AGENDA FOR THE CANTERBURY BANKSTOWN LOCAL PLANNING PANEL MEETING

8 December 2025 - 6.00 pm

1 16-22 Pheasant Street, Canterbury

Demolition of existing on-site structures and construction of a multi dwelling housing development of 18 two-storey dwellings with associated landscaping and swimming pool above a basement garage

Figure 1: Existing site form Source: Detailed Survey – Axiom Spatial Surveyors Pty Ltd

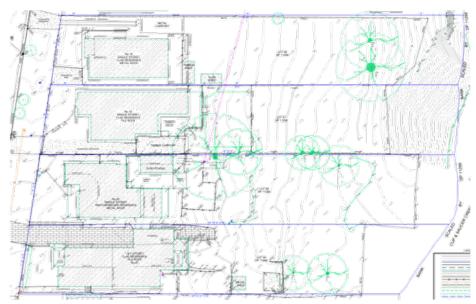
The four lots that constitute the site are regular in shape, but each have an irregular rear (western) boundary, assumed to have been scaled by the banks of Cup and Saucer Creek at the time of subdivision. The existing built form across the lots comprises three single storey clad and weatherboard dwellings and one double storey clad dwelling. Ancillary structures include carports, sheds and a studio. The site contains ten trees and located forward of the site boundaries of 16 and 18 Pheasant Street are three shrubs.
